RE: North Bullitt PSC - BG 24-192 - Change Order 18 - Curtainwall and Belltower
Revisions **DC**

Change Order

ARCHITECT'S SUPPLEMENTAL INSTRUCTION

PROJECT:	Phase II Athletics - Bid Package No. 2 North Bullitt Field House Bullitt County Public Schools	SUPPLEMENTAL INSTRUCTION NO.:	BP2-17
OWNER:	Bullitt County Public Schools 1040 Highway 44 East Shepherdsville, KY 40165	DATE:	10-Aug-2025
TO CONTRACTOR:	Calhoun Construction Services, Inc. 7707 National Turnpike Louisville, KY 40218	ARCHITECT:	Studio Kremer Architects 1231 S Shelby Street Louisville, KY 40203
		ARCHITECT'S PROJECT NO.:	2023-50 BG# 24-192

Revised Drawings: A2.05 NBHS, A2.06 NBHS, A6.13

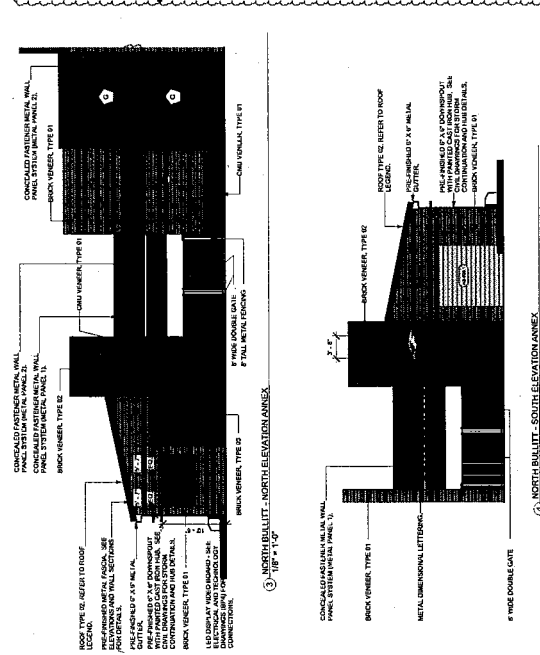
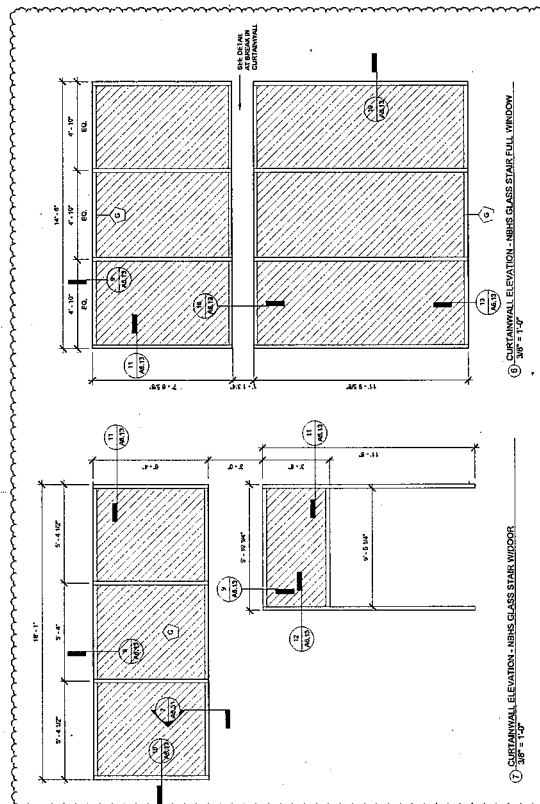
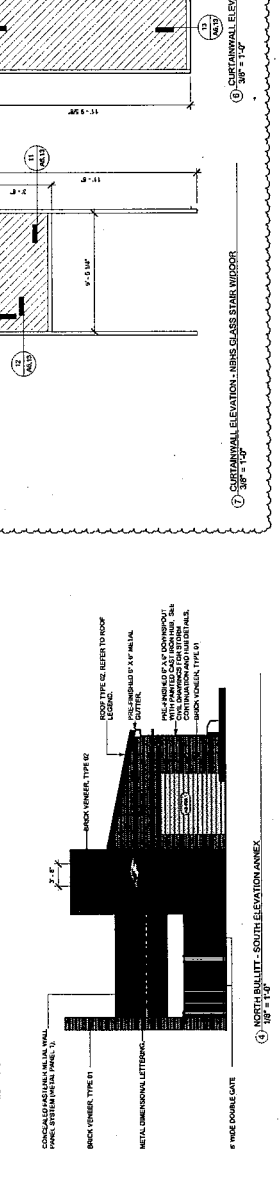
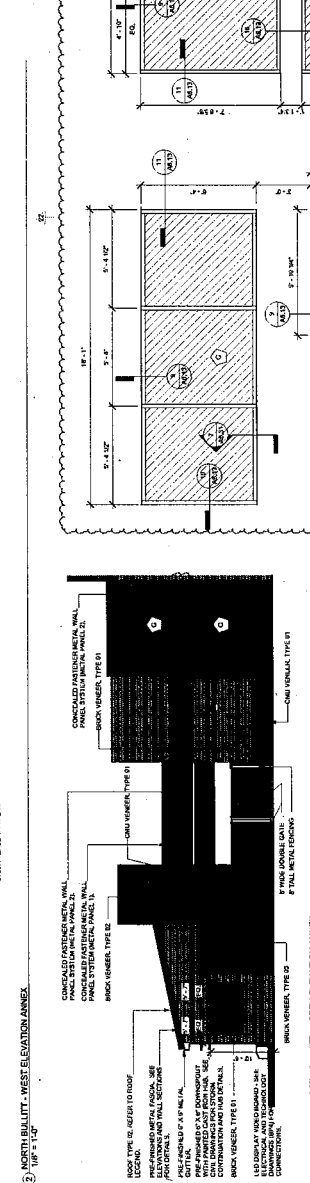
Item 1: Refer to Revised architectural drawings showing revision to curtainwall system at Glass Stair to coordinate with Structural Detail "E"/S4.4. Curtainwall running parallel with Grid Line BN.3 to be provided in two sections.

- a. A2.05 NBHS - Curtainwall Elevations revised to show two separate sections. Curtainwall Tags added.
- b. A2.06 NBHS - Curtainwall Elevations added to drawing.
- c. A6.13 - Curtainwall Detail #16 added showing framing between two curtainwall sections.
